Public Input No. 50-NFPA 24-2019 [Global Input]

Public Input No. 37-NFPA 24-2019 [Section No. 1.1]

Figure A.7.3.1 Typical Dry Barrel Hydrant Connection

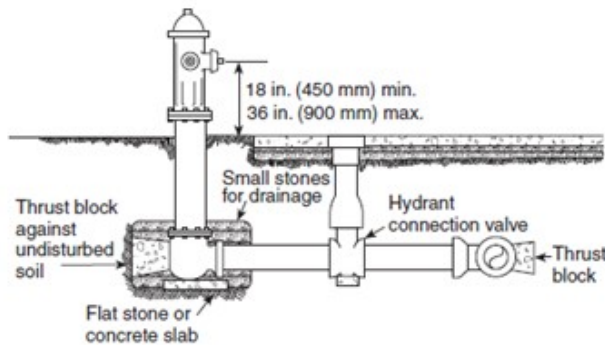
Delete existing Figures A7.3.1(a) and A.7.3.1(b) and replace them with the following new Figure A.7.3.1:

Statement of Problem and Substantiation for Public Input

This proposal is to clarify that only dry barrel hydrants require a bed of stone for drainage. Wet barrel hydrants are not equipped with drain ports.

Statement: This proposal is to clarify that only dry barrel hydrants require a bed of stone for drainage. Wet barrel hydrants are not equipped with drain ports.
